From: Michael Clements
Sent: 15 July 2021 15:33
To: Ailsa Teasdale <a.teasdale@northyorkmoors.org.uk>
Cc: Niall Roberts
Subject: Planning Application Ref. NYM/2020/0702/FL

Re: Planning Application Ref. NYM/2020/0702/FL - erection of 8 no. single storey lodges to provide 12 no. woodland rooms ancillary to existing Hotel with associated linkage paths at the Raithwaite Estate, Whitby.

All Officer Comments

Woodland Room Layout Previously Submitted

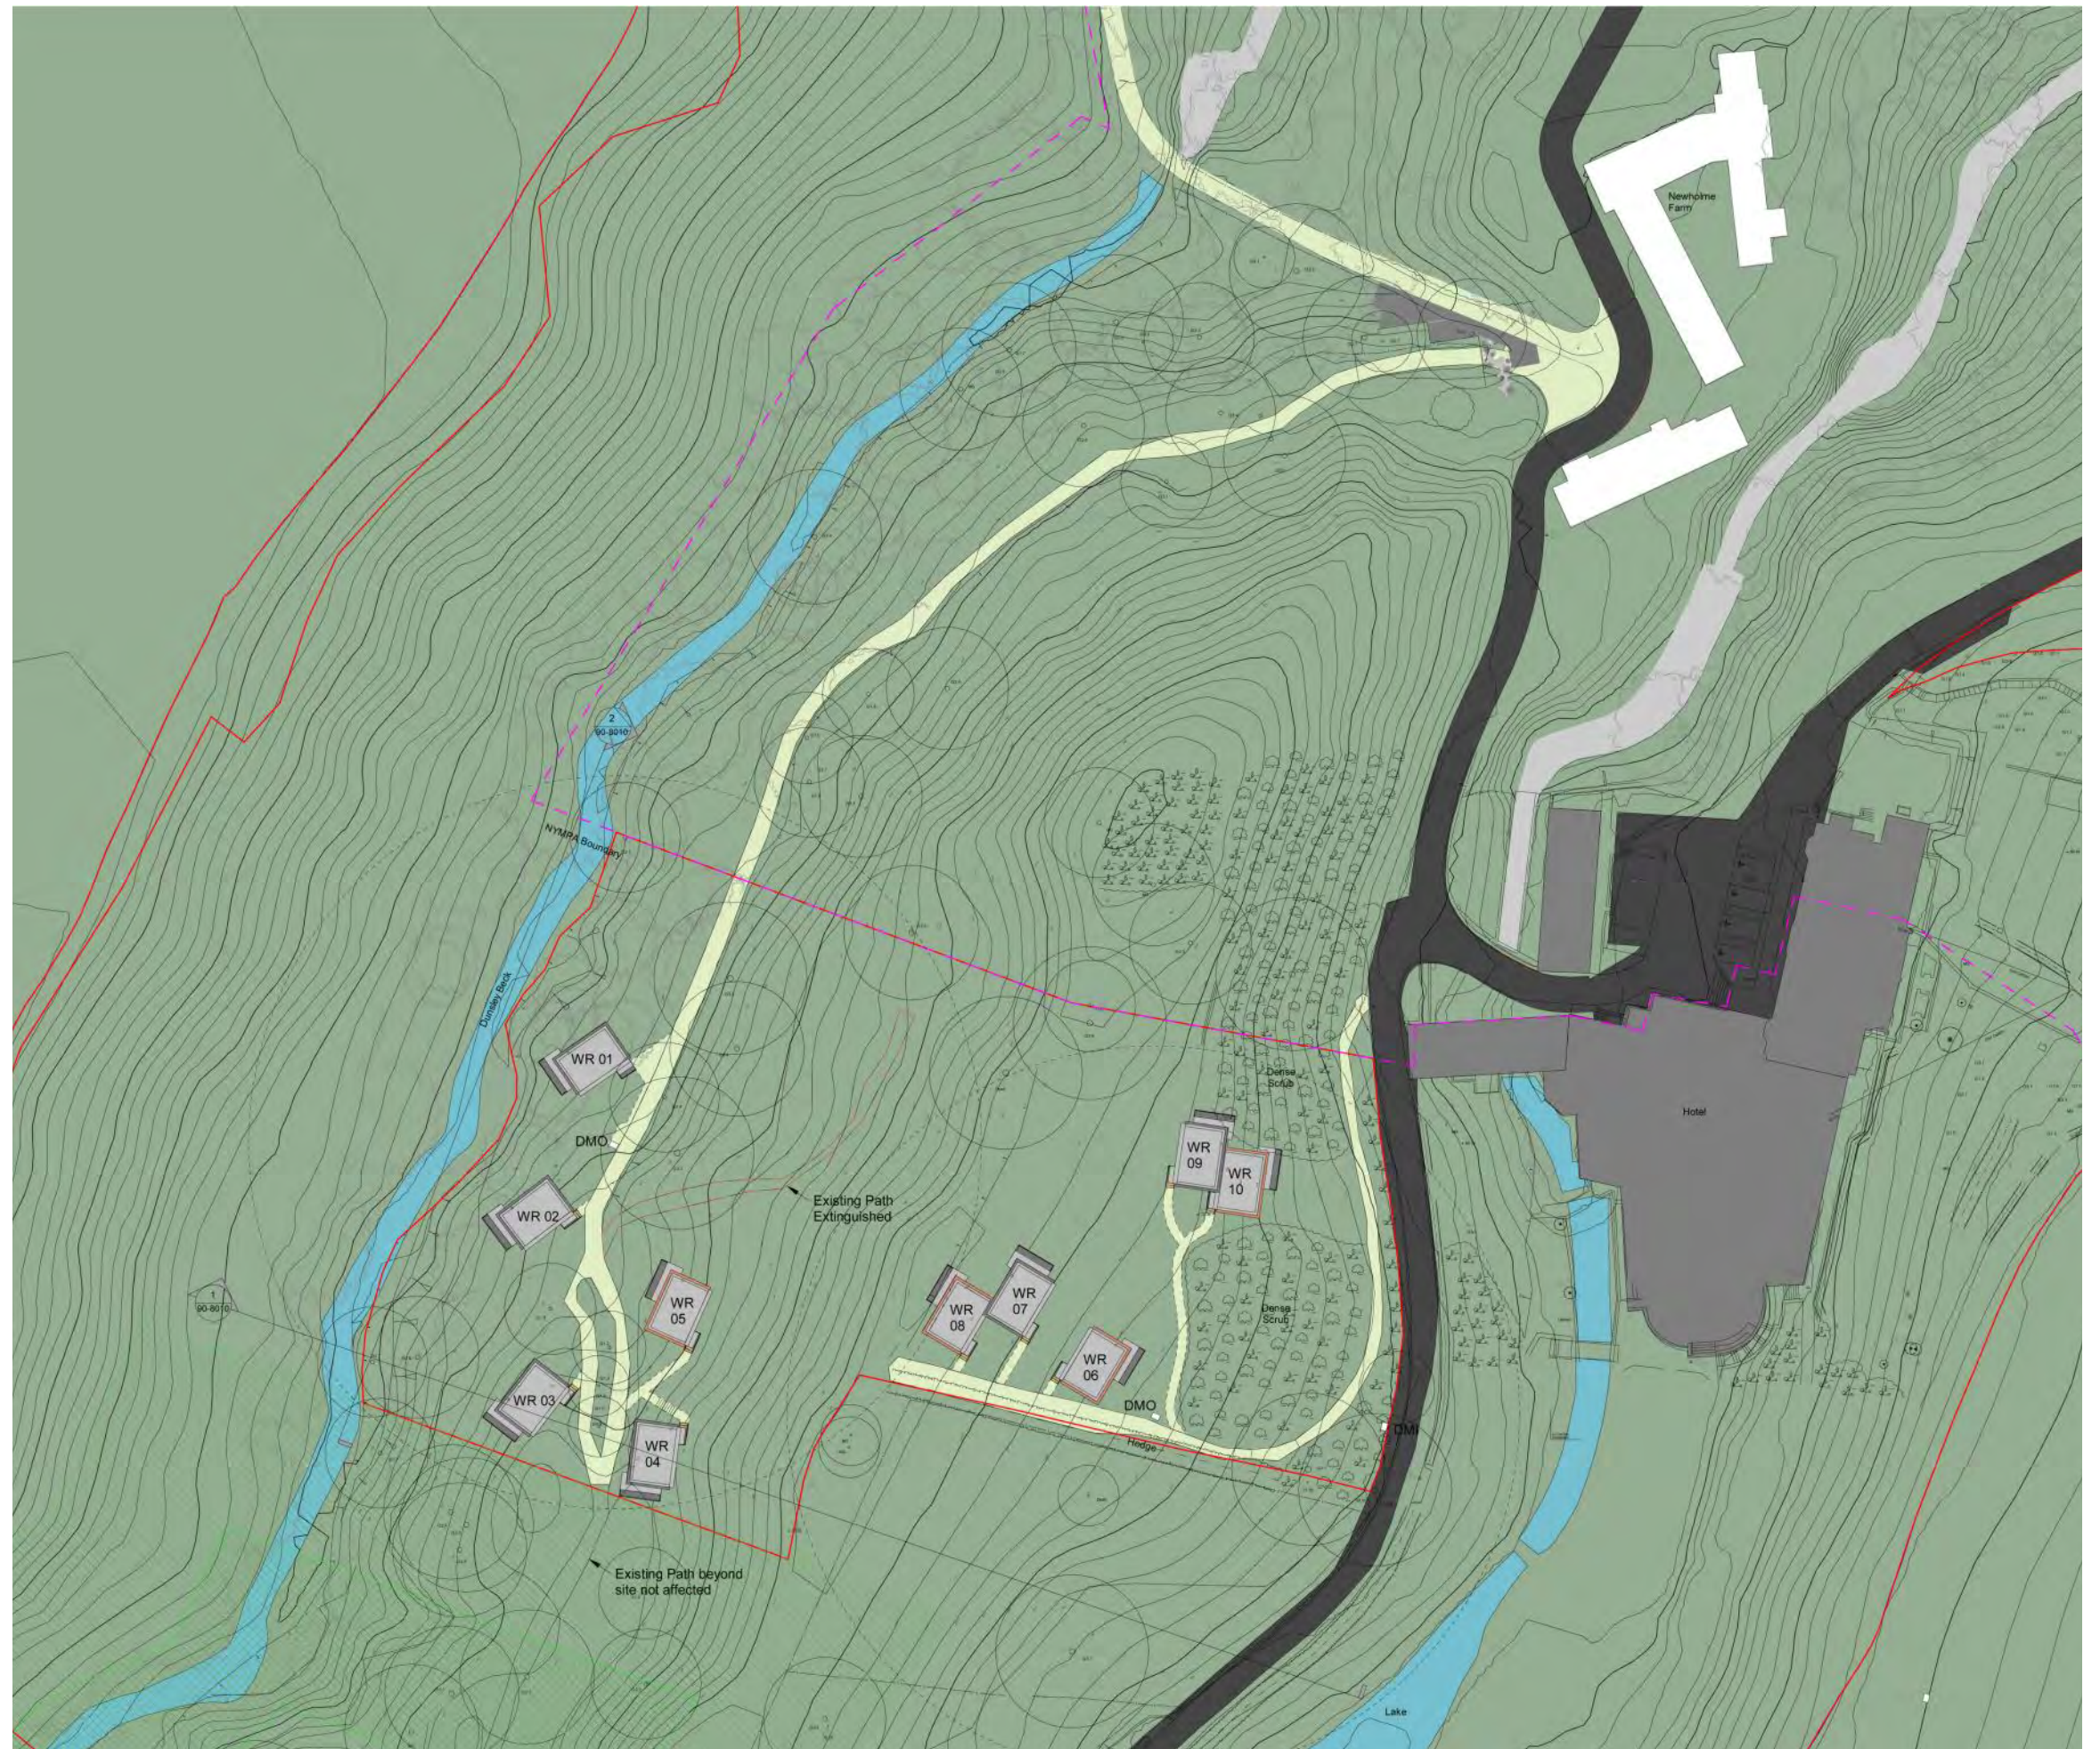
Over the course of subsequent design development, and in response to concerns raised around the impact on the ecology and wildlife of the woodland, the layout has been further amended to reduce the number of units from the original brief of 12, to 10 units.

- A reduction in woodland area affected by the development. This is achieved by positioning the woodland rooms in two independent clusters of 5 units each. The first grouped around the existing track through the woodland along Dunsley Beck, the second as a cluster set into the woodland edge, opposite the existing hotel.
- The woodland rooms in the woodland have been positioned to be accessible from the existing tracks, with the number of new access paths through the woodland significantly reduced.
- A section of existing track running up the woodland slope is to be extinguished to contain human activity to a small area as possible, and restore a wildlife path along a North/ South route, uninhibited by development.
- Buggy turning is still available along the existing tracks, and will be the only traffic permitted to use the tracks

Revised Woodland Room Layout - Finetuning

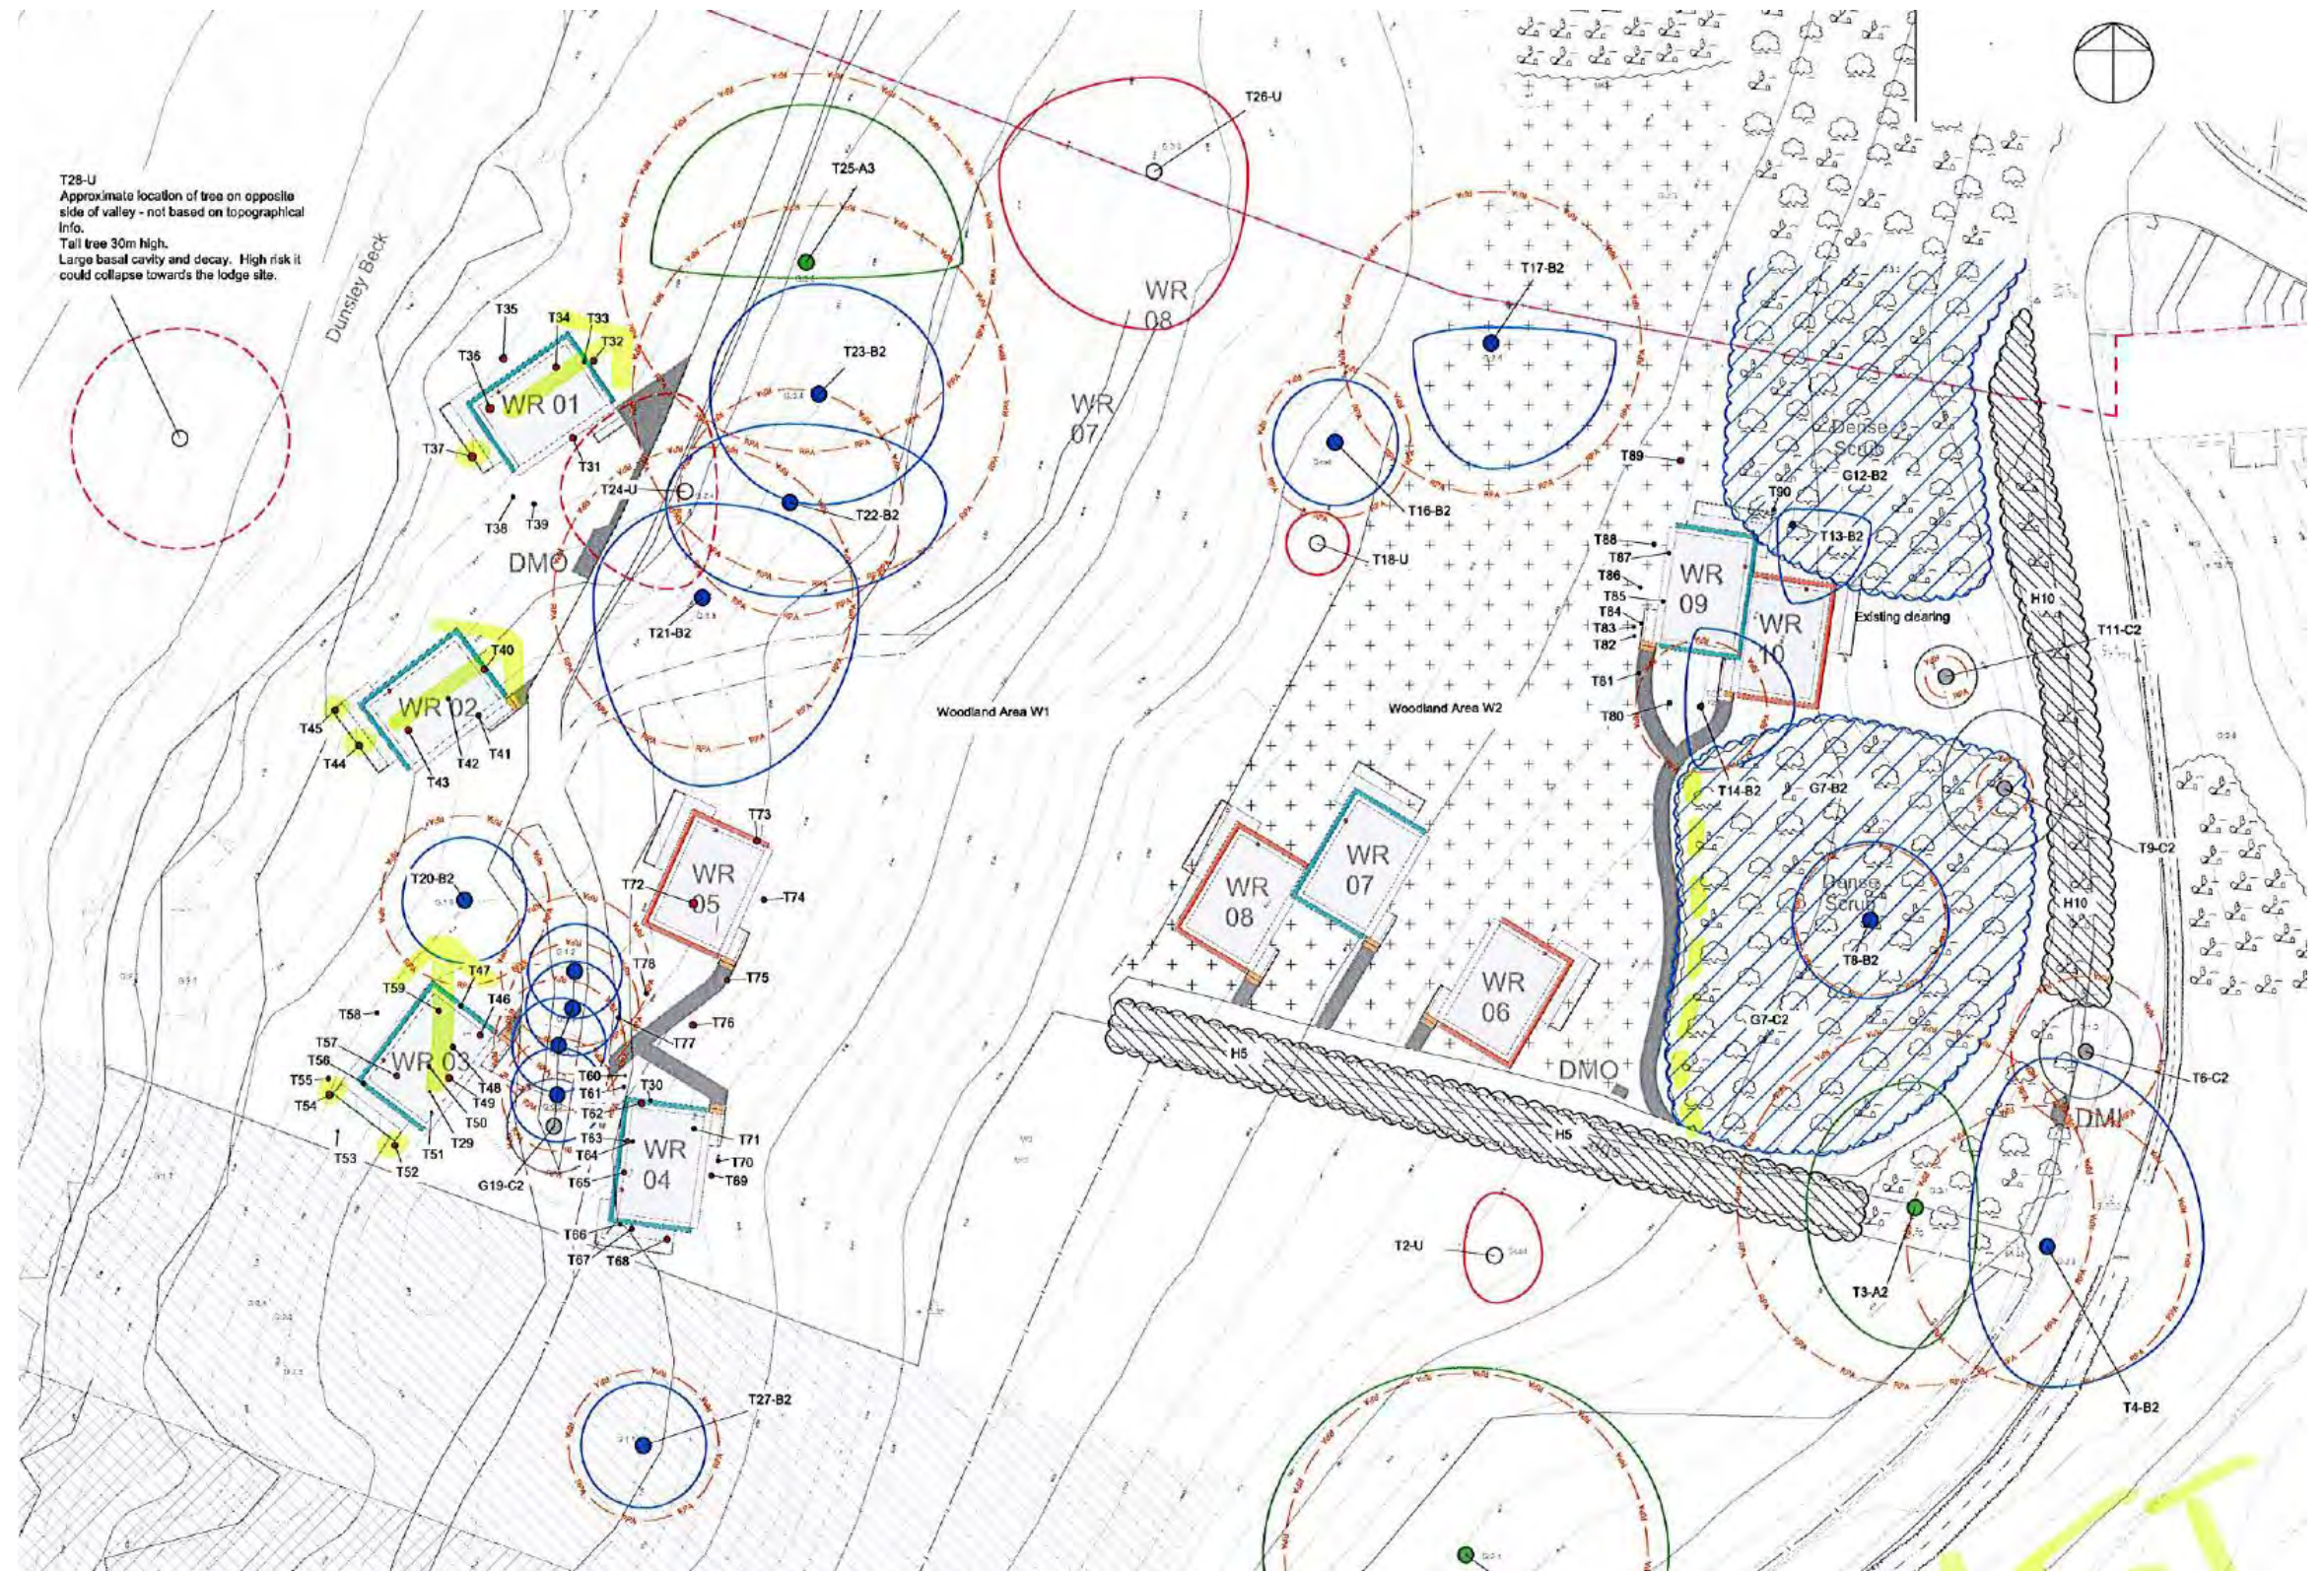
With the layout revised, the outline of each lodge was set out on site using pegs, and a more detailed survey of trees and ecology was undertaken and the layout fine-tuned to ensure the impact was reduced further. This led to the following tweaks, to give the final submitted layout:

These tweaks have given rise to the final layout proposed, which is shown on the revised submitted drawings.
